Modification Bulletin

Model: Russian-C2 ADF (DF75)		Date: 4-Jul-02	No.: MB386001
Modified Article: Magnet Catch		Prepared by: S. Tomoe	
From: Technical Services sec. Service Planning Dept.			
Reason for Modification:	<input type="checkbox"/> Parts catalog correction <input type="checkbox"/> To facilitate assembly <input type="checkbox"/> Part standardization	<input checked="" type="checkbox"/> Vendor change <input type="checkbox"/> To improve reliability <input type="checkbox"/> Other	<input type="checkbox"/> To meet standards ()

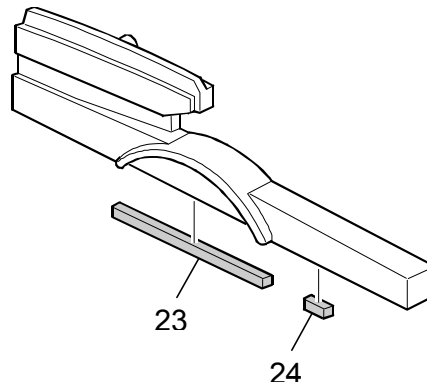
When the document approaches the transport rollers, it can sometimes contact the pullout lever due to warping in the left cover. The left cover has been changed to reduce the possibility of this happening.

Old part number	New part number	Description	Q'ty	Int	Page	Index	Note
<i>B386</i> 4841	<i>B386</i> 4842	Left Cover	1	X/O	3	8

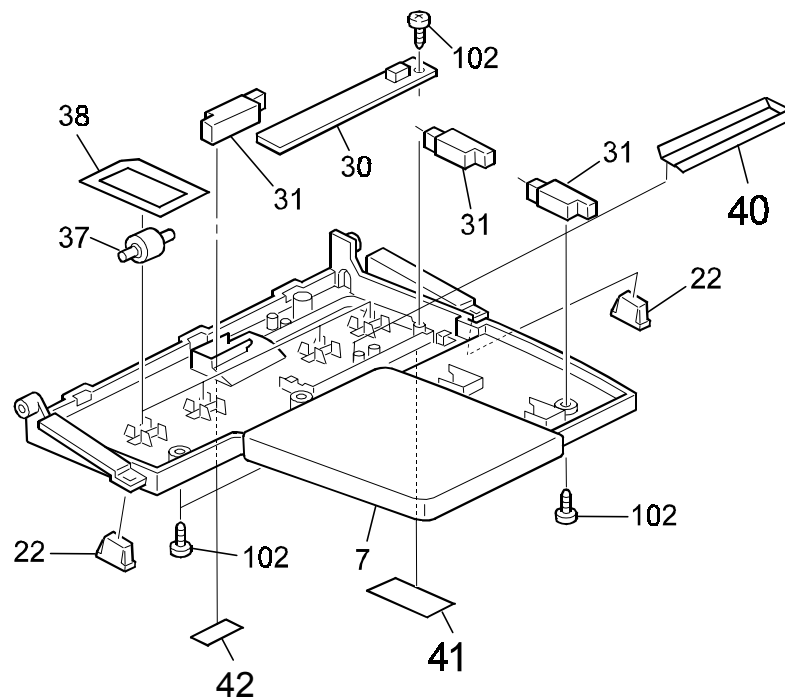
To cover the holes near the sensors and provide further shielding from static electricity, the following seals have been newly added.

New part number	Description	Q'ty	Page	Index	Note
B3864691	Mylar Seal - 28X107	1	5	41	
B3864692	Mylar Seal - 16X45	1	5	42	
B3864693	Mylar Seal	1	5	40

NOTE:

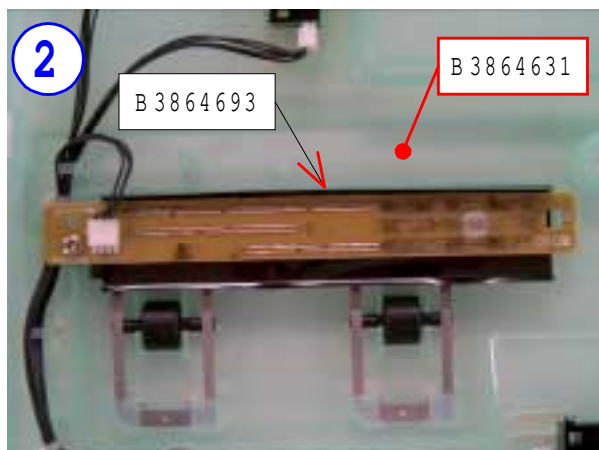
The Mylar Seal (B3864693) should be positioned under the Paper Size Sensor Board (B3865540) as shown:

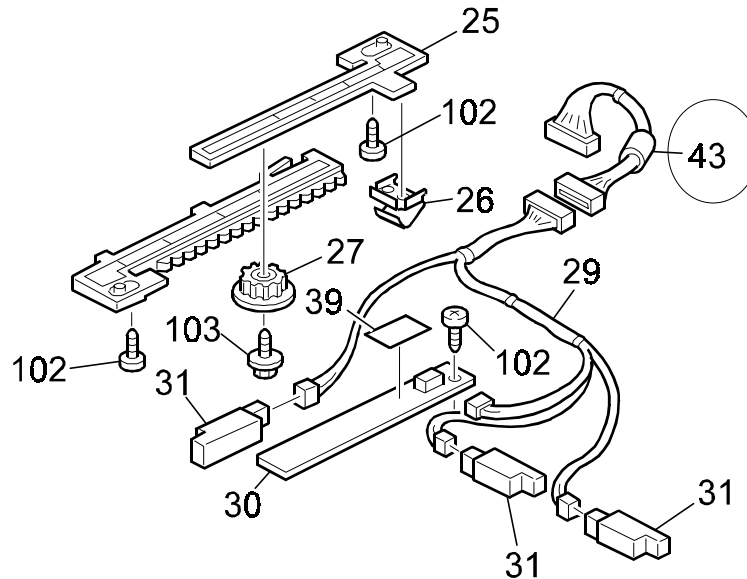
To increase the latitude against electromagnetic interference when this ADF is installed on the Model U-C1, a Relay Harness has been added.

Old part number	New part number	Description	Q'ty	Int	Page	Index	Note
A8595702	B4895715	Original Tray Harness	1-1	X/O	5	29	
	B4895713	Relay Harness – Original Tray	0-1		5	43

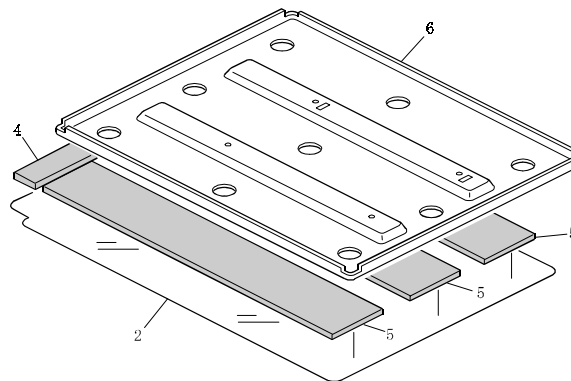
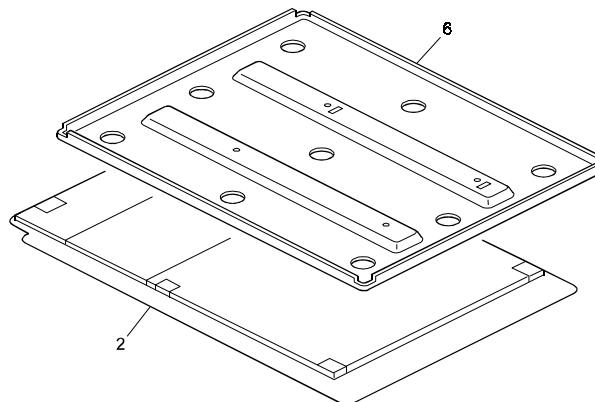
When this ADF is installed on the Model U-C1, the left side of the Platen Cover Sheet rides on the left scale, making it necessary to adjust the sheet position to ensure proper scanning. To facilitate this, the sheet has been changed so that it can be removed easily (fixed by Velcro), and the sheet and sponges have been registered as an assembly.

Before modification:

After modification:

Old part number	New part number	Description	Q'ty	Int	Page	Index	Note
G4123721		Platen Cover Sheet	1-0		15	2	
A8593614		Sponge – Left Platen Cover	1-0		15	4	
A8593613		Platen Cover Sponge	1-0		15	5	
	► B3863630	Sheet Ass'y	0-1	X/O	15	2

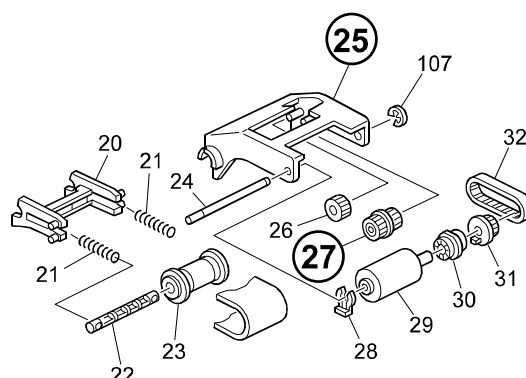
The following have been changed for the Russian-SC to further ensure that the shaft of the Pickup Holder for the Pulley is not damaged. This change has also been applied to the Russian-C for purposes of parts standardization.

Note: When installing for the first time, the above parts must be replaced together as a set.

Old part number	New part number	Description	Q'ty	Int	Page	Index	Note
A8592151	G4123821	Holder - Pick Up	1	X/X	7	25	
A8592168	G4123831	Pulley - 22Z	1	X/X	7	27

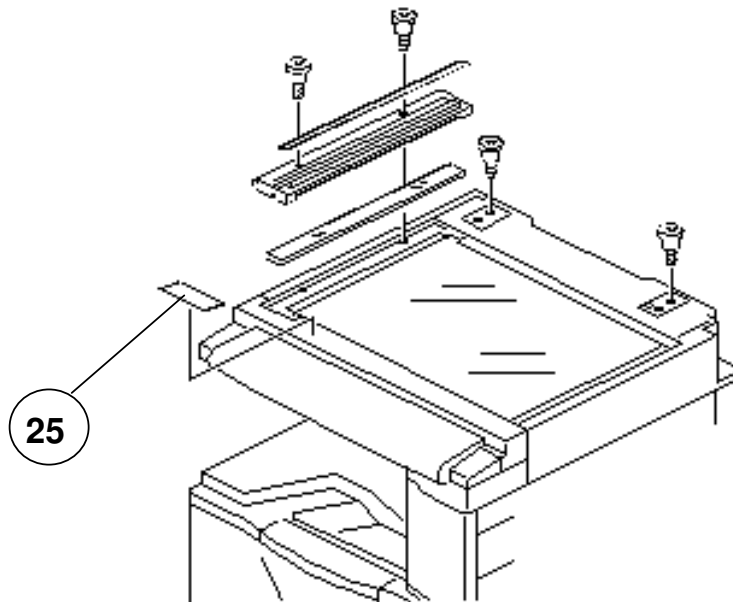
The following decal has been added to prompt the operator to clean the exposure glass to ensure black lines do not appear on the copy.

Old part number	New part number	Description	Q'ty	Int	Page	Index	Note
	G5646087	DECAL:EXPOSURE GLASS:MACHINE OR COP	0-1	X/O	3	25
